RE: Silver Ave Townhomes

Grading and Drainage Plan

Engineer's Stamp Date 8-18-16 (File: K16D072A)

MASTER GRADING & UTILITY PLAN

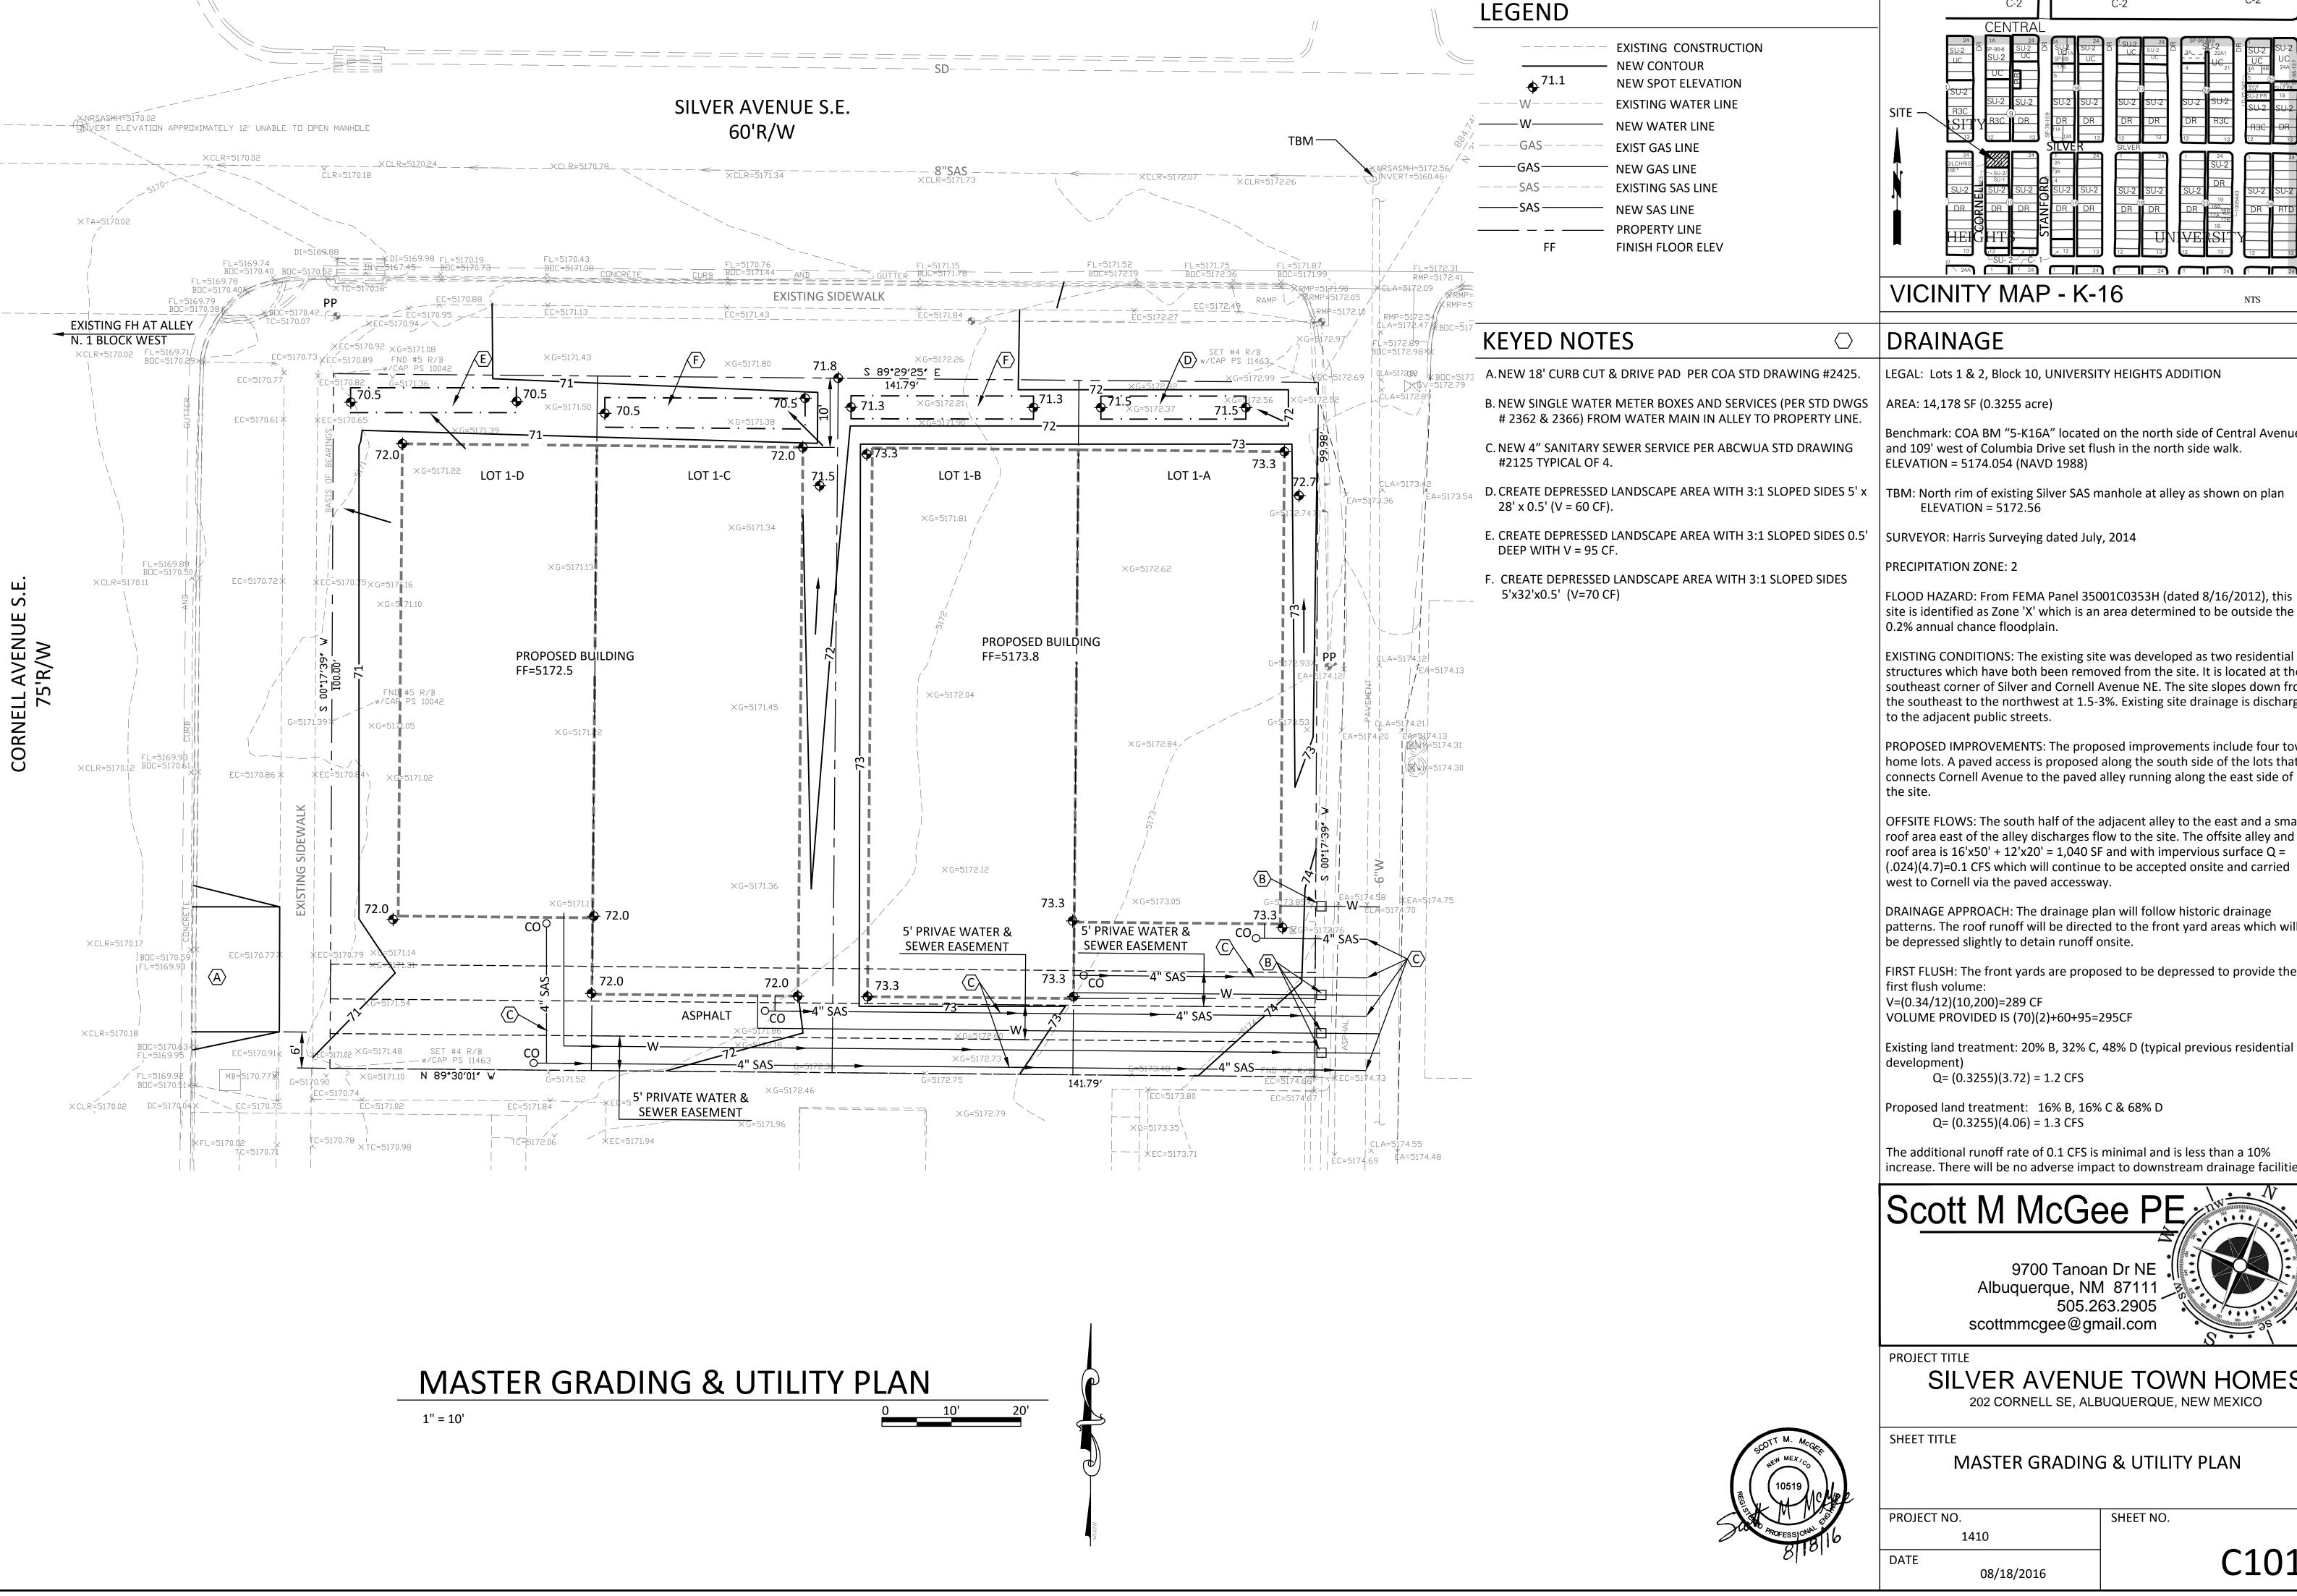
Based upon the information provided in your submittal received 8-30-2016, the above-referenced plan is approved for Building Permit.

Please attach a copy of this approved plan in the construction sets when submitting for a building permit. Prior to Certificate of Occupancy release, Engineer Certification per the DPM checklist will be required.
